P&Z STAFF REPORT

Case: **RZ16-0100 – 120 West Wieuca Road**
Staff Contact: Paul Leonhardt (pleonhardt@sandyspringsga.gov)
Report Date: October 6, 2016

To **rezone** from A (Medium Density Apartment District) to A (Medium Density Apartment District) to allow for the construction of 25 townhouse units, to allow 11 of 25 previously approved townhouses to be constructed with a height exceeding the conditioned 40-foot height limit, and to allow all driveways to have lengths less than the previously conditioned 18 feet.

SITE PLAN
 SHEET 1 OF 1

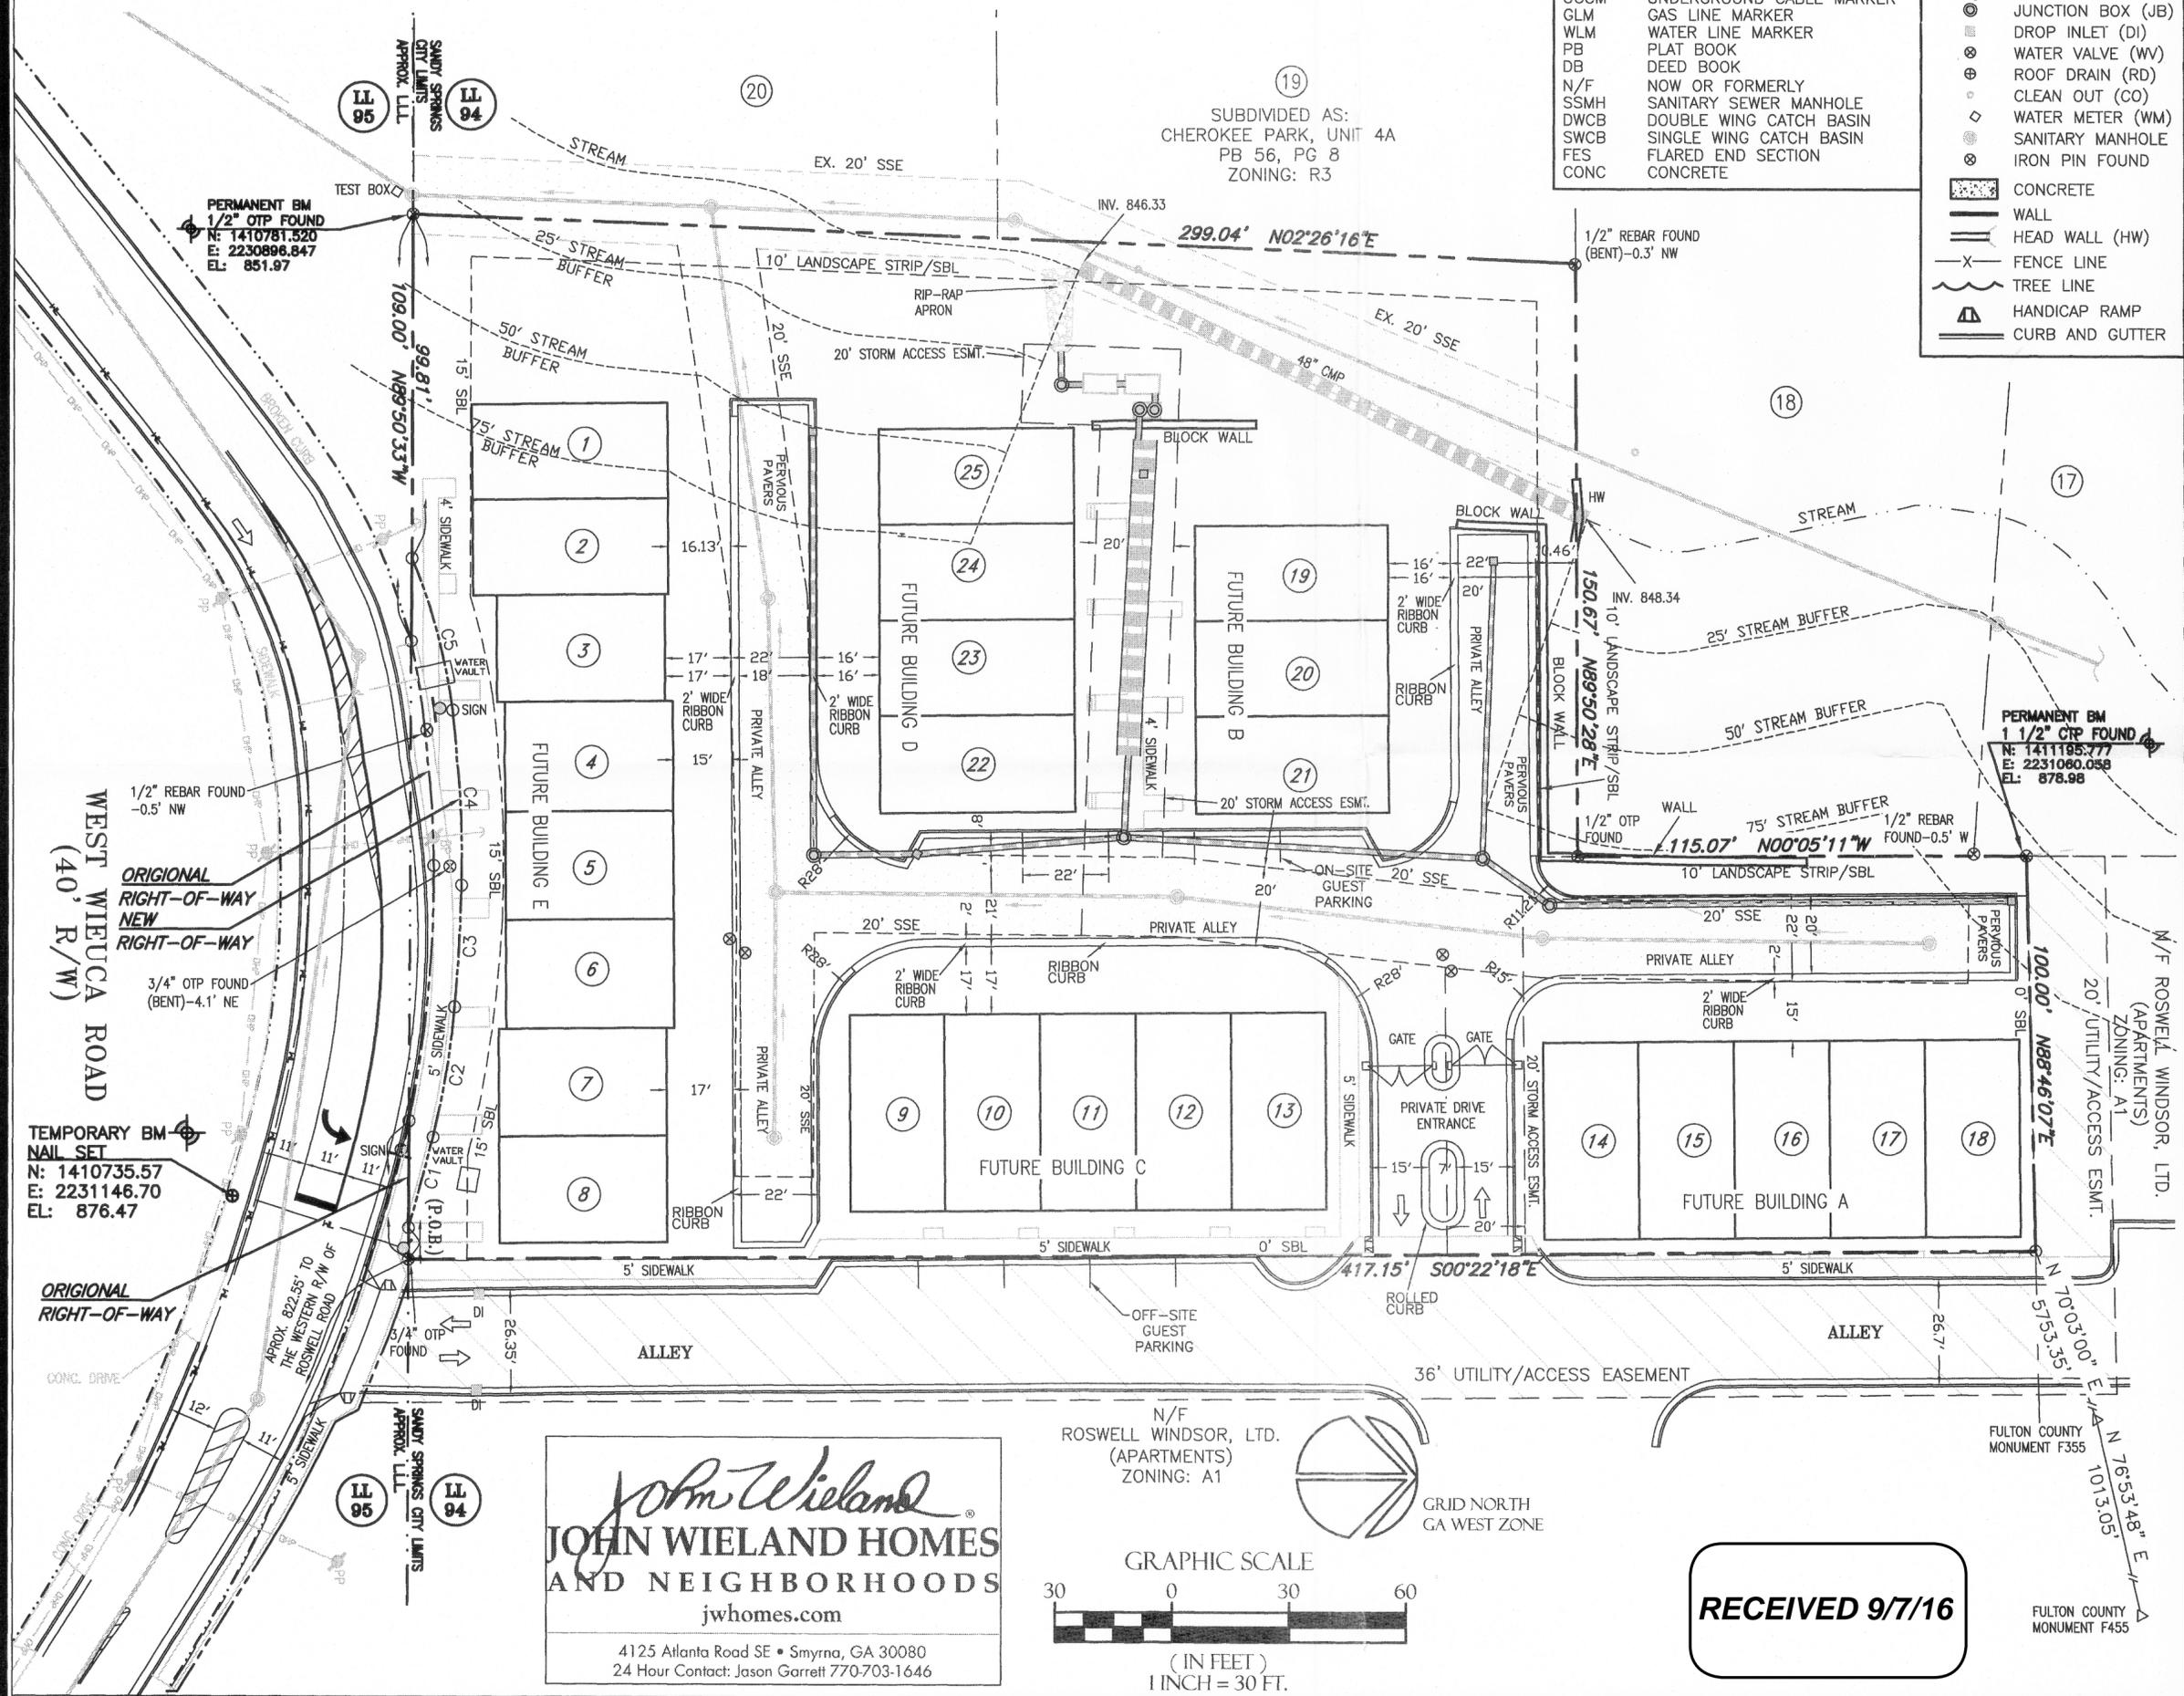
The reduced driveway length may lead to parked cars encroaching into the development’s private drive aisles. Due to the reduced approved street width of 20 feet, any reduction in driveway length will impact the safe passage of vehicles within the development and may impact the ability of emergency vehicles to access the units.

To illustrate a worst-case scenario: Units 4 and 22 are on opposite sides of the private street to the Southwest of the property and they will have 15- and 16-foot driveways respectively. If two 19-foot vehicles are parked only one foot away from the garage door, they will each hang over four feet into the street. The resulting free-and-clear width 11 feet as opposed to the minimum 20 feet agreed on in the rezoning process and the 24 feet desired by the City Fire Marshall and the City Public Works department. Emergency vehicles would potentially not be able to navigate the development and fender-benders are to be expected during the day-to-day navigation in such narrow surroundings.

In response to the request to remove the zoning condition requiring the depth of driveways to be 18', it is not recommended to allow any driveways shorter than 18' due to reasons of safety and operations. From a safety perspective:

The minimum roadway width for this type of development is 10' lanes, excluding curb and gutter. With a gutter width of 18", the minimum total roadway width from face-of-curb to face-of-curb is 23'. The roadways on the plans are 20', including the gutter width. This reduction in effective roadway width means an increased difficulty in navigating the site, and an increase in risk of fender-bender/property-damage-only type crashes. The concern for efficient traffic flow internal to the sight is not significant or note-worthy.

Staff finds that the proposal is not in conformity with the policies and the intent of the Comprehensive Plan and would create unsafe vehicular circulation conditions. Therefore, staff recommends **DENIAL** of RZ16-0100.
